STEREO CONFIGURATION CHANGE REQUEST

TITLE	SEPT Sin	gle ended interface		CLASS:			NUMBE	R:			
	Office							Ι					
Use	Only							II	DATE:				
CONFIGURED ITEM:						ORIGINATOR: PRIORITY:							
						Name: Dave Curtis							
STS N	Number:			Payload: STEREC)	Organization: U.C. Berkeley				\checkmark	Rou	ıtine	
Component :				Experiment: IMPACT		Phone: 510-642-5998					Urgent		
Component Part #: Seri				Serial #:		Email: dwc@ssl.berkeley.edu					Em	ergency	
TYPE OF REQUEST:				RESPONSIBLE		IMPACTS:							
				ORGANIZATION/INDIVIDUAL:				(If yes attach additional pages)					
	Configuration									,			
	Deviation #		#					COST	:	Yes	\checkmark	No	
\checkmark	√ Waiver #												
Other:								SCHE	DULE:	Yes	\checkmark	No	
REA	SONS FO	DR CHA	ANGE:			RET			RETEST	ETEST REQUIRED:			
\checkmark	√ Improvement		Test/P	ayload Failure	1	New Document:	No						
	Reliabilit	÷		cation Requirements		Other:			Yes				
				additional pages as required		Control or d G	ו דיםיםי		CEDT NO	T. T. Linear	-1-4-	a tha

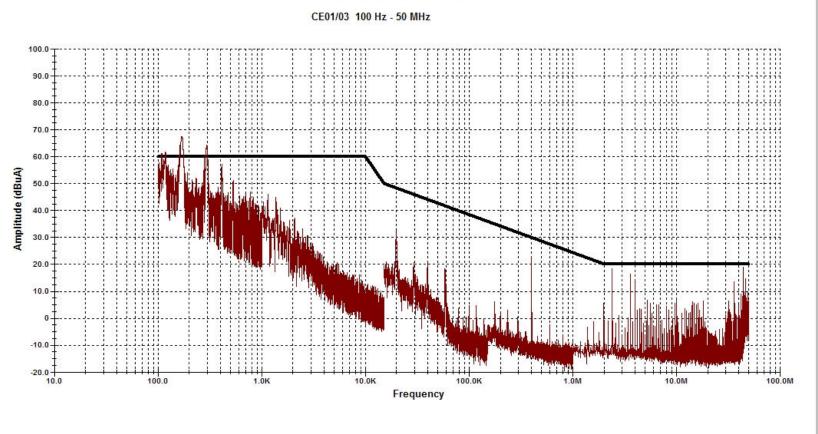
Use single-ended digital interfaces between the SEP Central and SEPT-E, and SEPT-NS. This violates the Project EMC requirements as called out in 7381-9030-, section 3.2.2.4.													
r roject ENTC requirements as caned out in 7301-3030-, section 5.2.2.4.													
RATIONALE (Attach additional pages as required):													
The original design as shown in the attached schematic was quasi-differential in that the 50													
ohm resistor isolated the signal return from the instrument return. This was deemed													
accepttable (without waiver) by the EMC committee when it was first proprosed.													
	We recently discovered that in the SEPT units a jumper was left across the 50 ohm resistors in												
												ors in	
the receiver of the serial digital signal (the resistor on the right in the circuit drawing). Meanwhile all 4 flight SEPT units have completed environmental testing, and the FM1 u									its

MC tests. The resul									
				s attached, and sho									
	bonded	l to a n		nch top to simulate								vere	
	operati	ng).											
	To first	bia na	blom	and involve ensints		be 4 flight u	nite e	and a	.b.c.c.u.o	at voto d	b	: ala	
To fix this problem would involve opeining up the 4 flight units and subsequent retest which has significant cost and schedule implications. Based on the EMC test results we propse to fly													
the instruments as-is.													
DOCUMENTS/DRAWINGS AFFECTED (Document No./Title/Section) :													
AFFECTED (Check all that apply):													
FLIG	HT SYSTE	MS:				GROUND SYST	'EMS:						
1	Avionics			Electrical and Cables									
	Experime		chanical	Software/Firmware Other:					Othe				
Structures and Mechanical Other: Other: REQUIRED APPROVAL DATE:													
REQ	UIRED J	USTIFIC	CATION:						1				
											(Pa	ge 1 of 2)
